**AGENDA PACKET**

**JULY 18, 2023 MEETING**

**AGENDA**

**Tuesday, July 18, 2023**

Topographic Map

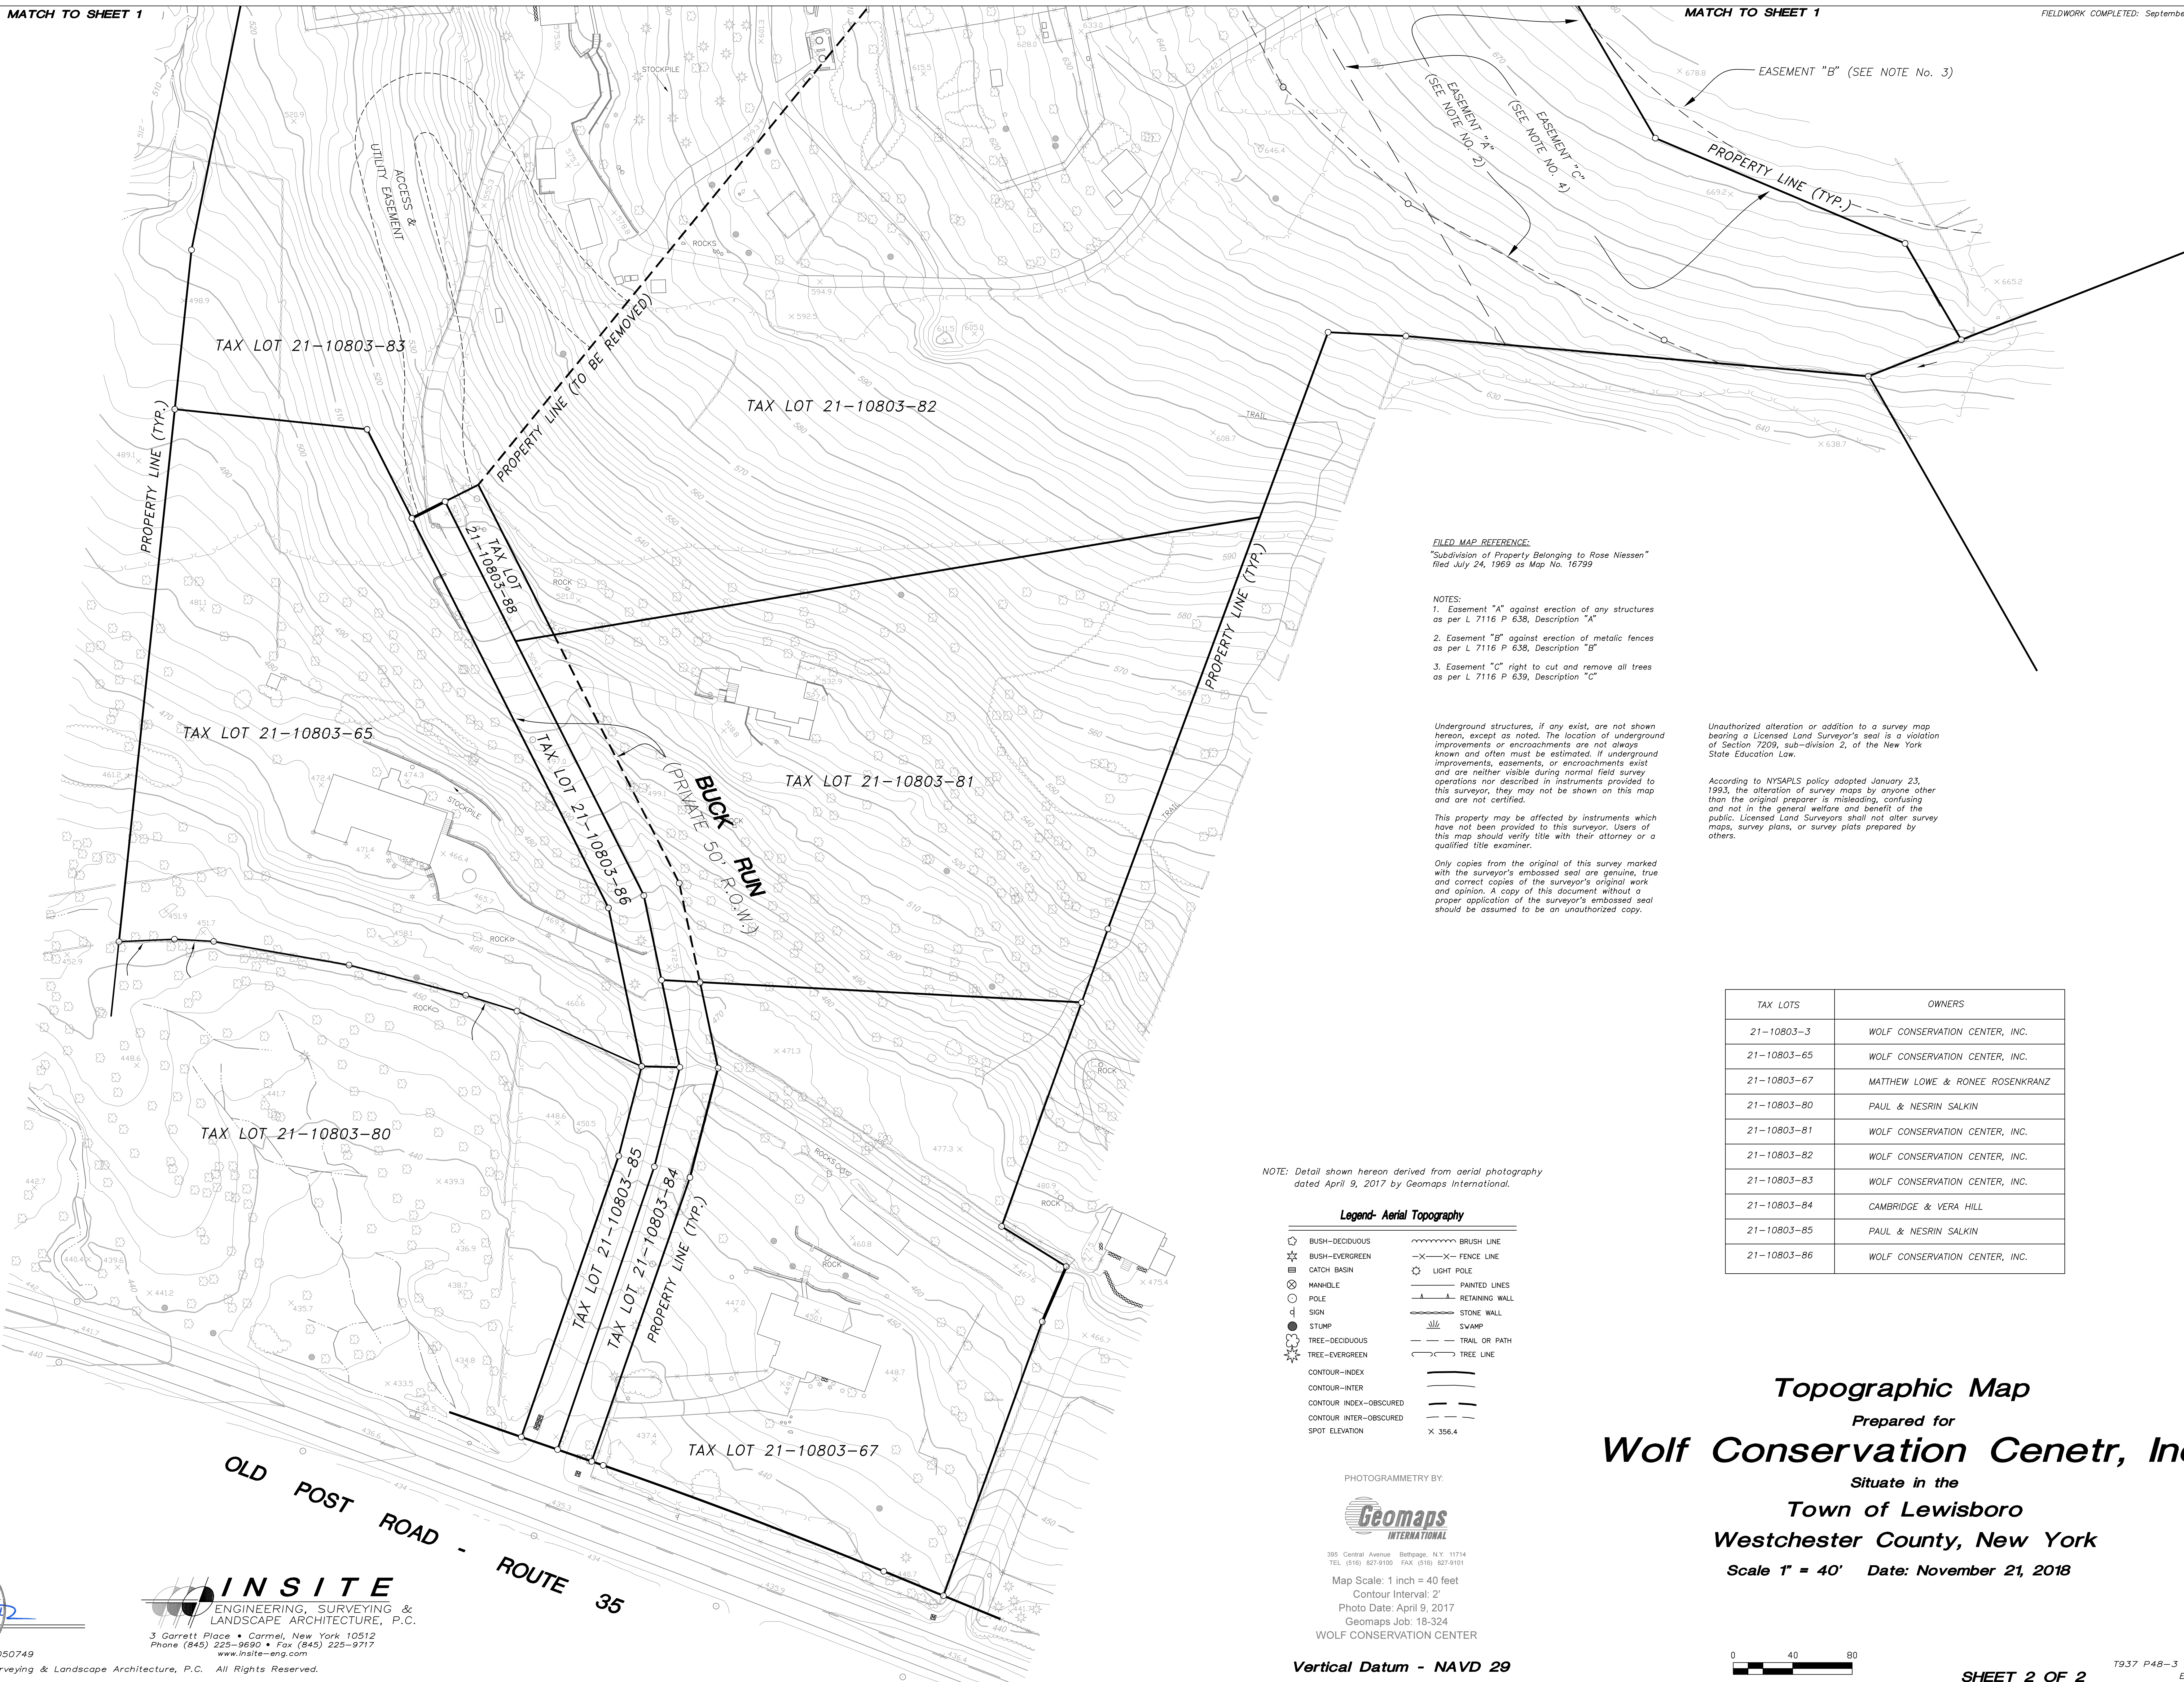
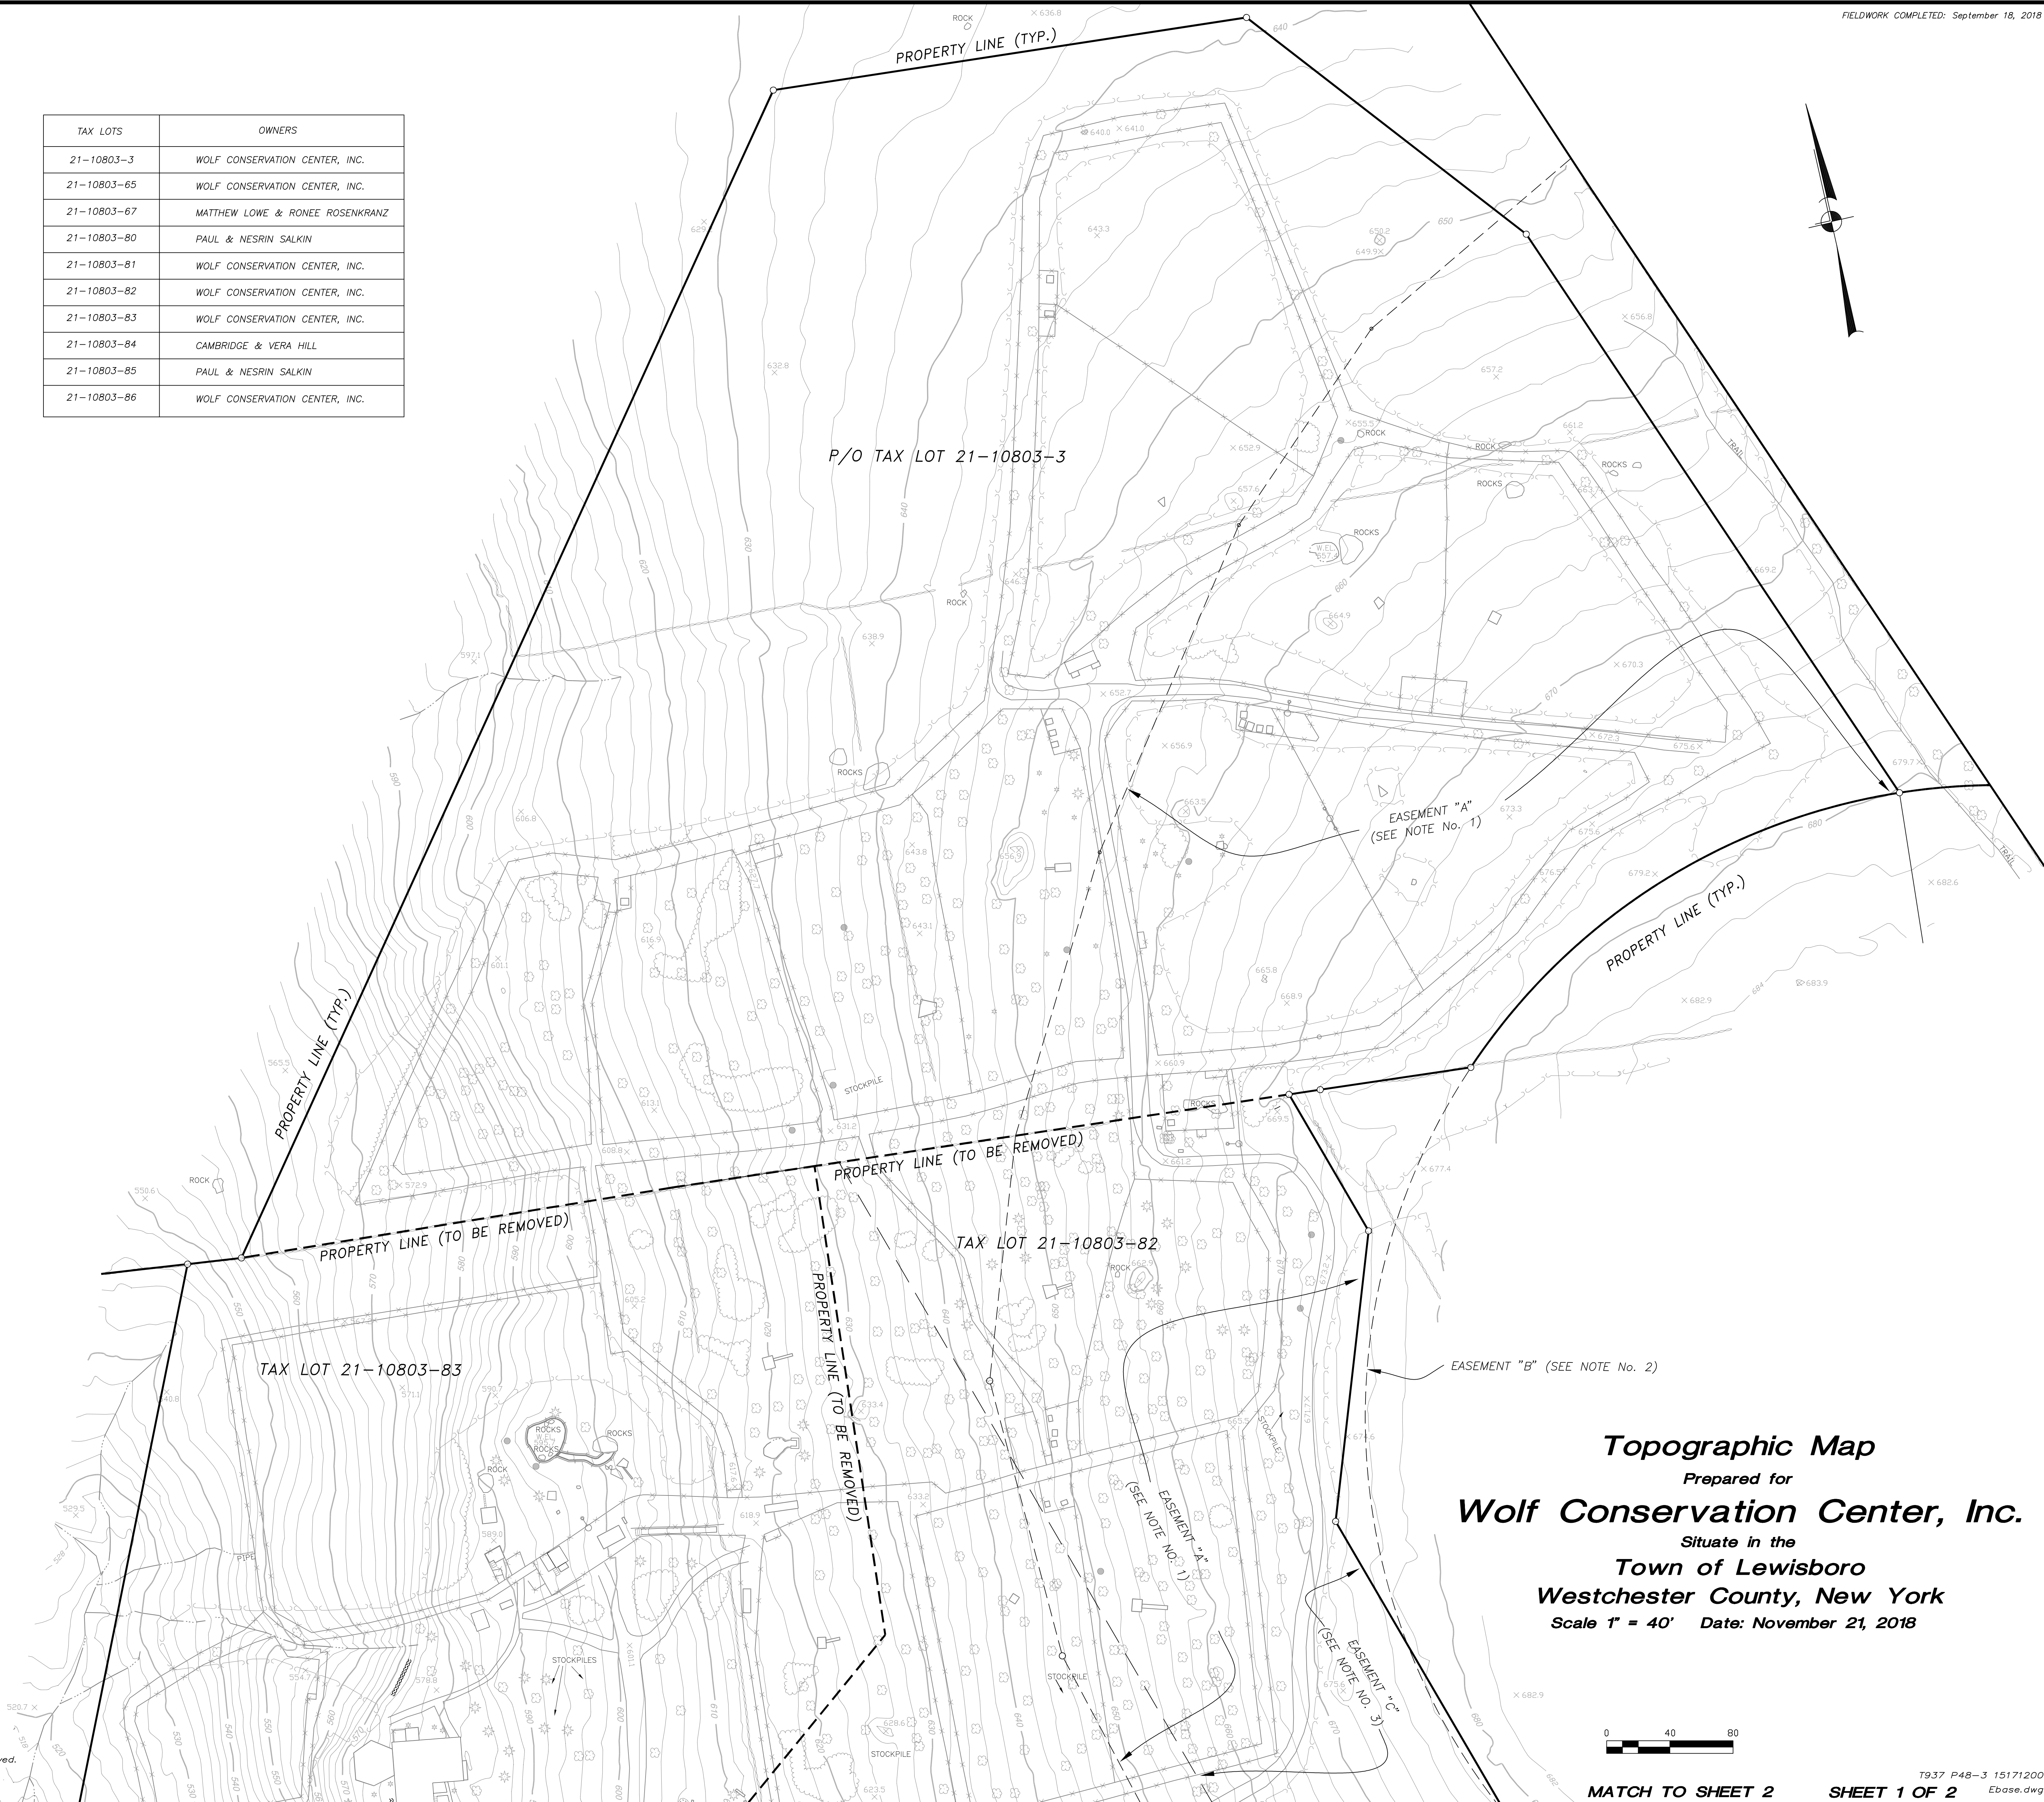
2. All existing potable water wells and septic systems should be illustrated on the Plat.
3. The off-site NYSDEC/Town wetland located adjacent to Route 35 and Buck Run, along with the Town's 150-foot Town wetland buffer, should be added to the Plat. A note shall be added to the Plat stating that all on- and off-site wetlands are regulated by the Town of Lewisboro and certain wetlands are co-regulated by the NYSDEC; NYSDEC wetland identification numbers should be provided.

4. A note should be added to the Plat referring to the use of Parcel 2 as a Private Nature Preserve under Section 220-43.2 of the Town of Lewisboro Zoning Code and indicating the necessity for a Special Use Permit, as issued by the Planning Board.

6. A note should be added to the Plat referring to the required area variance for the existing fence height.
7. The proposed new road name should be added to the Plat; the new name must be approved by the Town.

8. Easement "A" refers to Note #1 on the Plat which appears to be incorrect; please review all easement note references.
9. Provide ownership information for both parcels. A determination should be made as to whether the owners of Parcel 1 will need to sign the Plat.

10. The Planning Board signature block shall include the name of the chair and administrator below the signature line. Change the terminology to "Chairperson" and "Administrator".
